## SERVICE BULLETIN NO. MSB869-22

G 103C TWIN III SL                      S/N    35002 - 35051

**ATA-Code:**    N/A  
**C of G release hook**

G 103C TWIN III SL

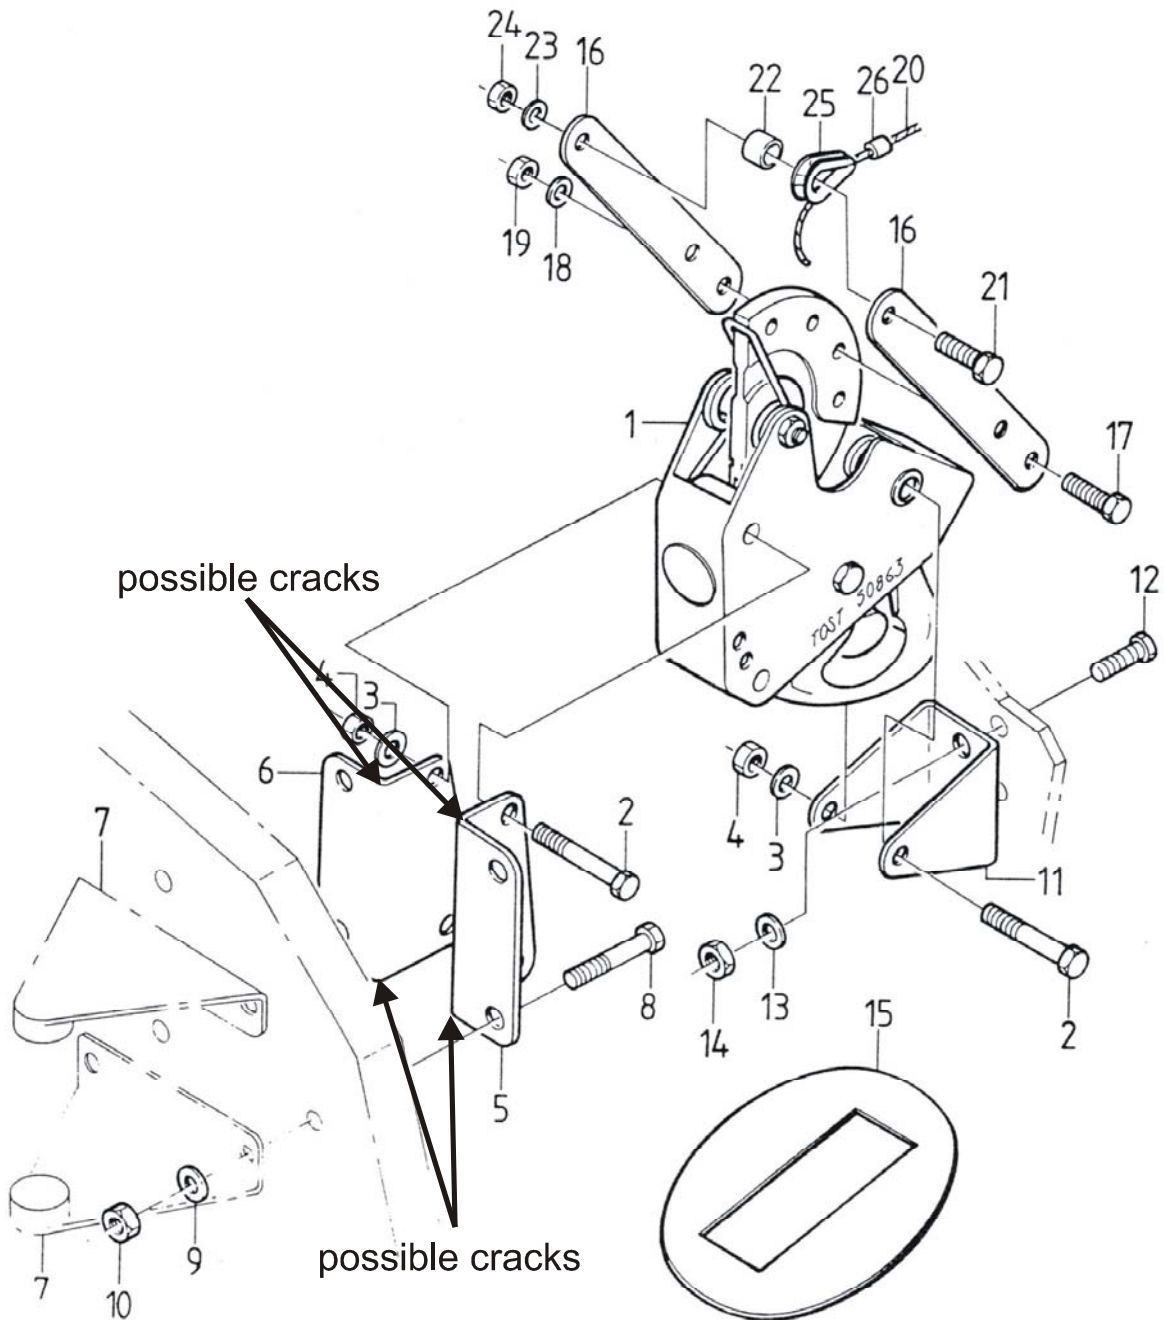
After long time of operation (i.e. towing using the C of G release hook) cracks at the forward C of G release hook attachment brackets might occur.

**1.8.1** The attachment brackets P/N 103B-2360.01 and 103B-2360.02 must be checked for cracks as follows:

- remove rear seat
- check the brackets for possible cracks, refer to illustration on page 2 (if necessary use mirror and pocket lamp)

**1.8.2** Both forward C of G release hook attachment brackets must be replaced as follows:

- remove rear seat
- remove L/H and R/H instrument panel cover
- remove **front** attachment of the C of G hook (item 2, 3, 4), loosen rear attachment (item 12, 13, 14)
- remove attachment brackets (page 2, item 5 and 6)
- install new brackets P/N 103B-2360.01/2 and 103B-2360.02/2

**Caution:** If cracks are determined, replace the brackets immediately IAW 1.8.2 !

**Note:** During the installation the new locking nuts, included in the mod set, must be used.

- install C of G release hook
- install L/H and R/H instrument panel cover
- install rear seat
- perform function test of the C of G release hook
